Applicant response to Further Advice under Section 35 of the Development Assessment Rules

Council reference: A006861516
Property details: 15 Ullswater Street, Virginia QLD 4014

Figure 1 Amended Site Plan

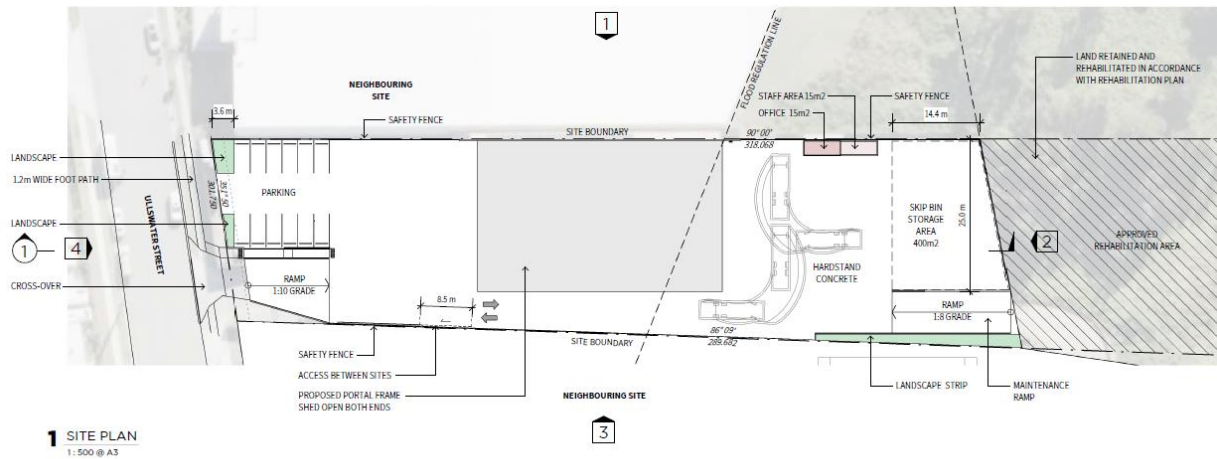
Item	Submitted Plans
5	<p>The submitted plans show alterations to the previously approved layout for the Waste Transfer Station but do not appear to include all items shown onsite through an aerial mapping assessment. This includes what appears to be a weighbridge on the southern side of the shed structure onsite.</p> <p>a. Provide amended plans which include all details of the development, including items such as a weighbridge, or confirm that these aspects are not part of the proposal and are intended to be removed from site.</p>

Item	
6	<p>The proposed plans show the removal of the site office, resulting in a lack of staff recreation area or amenities onsite. It is understood that a separate application has been lodged over the adjoining lots, however, this application is required to be assessed on its own merits and cannot rely on facilities on adjoining land. The site is required to provide its own area for staff recreation and amenities.</p> <p>a. Provide amended plans which demonstrate staff recreation area and amenities within the subject site.</p>

Item	
7	<p>The submitted plans show a skip bin storage area to the rear of the shed where previously carparking was allocated. It is assumed that all skip bins are to be stored entirely within the nominated area. However, further information is required in order to determine storage capacity is sufficient for the expected number of bins and that storage will still allow for manoeuvring at the rear area by vehicles within the site.</p> <p>a. Provide amended plans which show skip bins located entirely within the allocated area and provide further information on the expected storage capacity.</p>

<i>Provide swept paths from a suitably qualified RPEQ to ensure the safety and manoeuvring within the site is ensured, without conflicts with stored skip bins.</i>

Item	Landscaping
8	<p><i>The proposed removal of landscaping from the frontage of the site and the associated condition is not supported. The proposal is to incorporate landscaping to the frontage of the site that makes a positive contribution to the streetscape and incorporates bold landscape elements that complement the scale and bulk of the industrial form in accordance with PO12 of the Industry code. Provide a Landscape Concept Plan prepared by a suitably qualified Landscape Architect that:</i></p> <p><i>a. Incorporates a landscape buffer along the full length of the frontage of the site excluding the crossover that supports the provision of large shade trees that at maturity cast 50% shade cover over the frontage of the site. This appears to be achievable without needing changes to the parking layout</i></p> <p><i>b. Demonstrates the landscape buffer is to include understorey plantings made up of shrubs and groundcovers in mulch that will achieve full coverage of the landscape areas within 2 years of planting.</i></p>

Response: Refer to **Appendix A** and **Figure 1**, which shows the following:

- Removal of weighbridge (replaced with approved rehabilitation area);
- Site office and staff recreation area immediately west of the Skip Bin storage area;
- Skip Bin storage area; and
- Landscape strip between the car parking area and the front boundary.
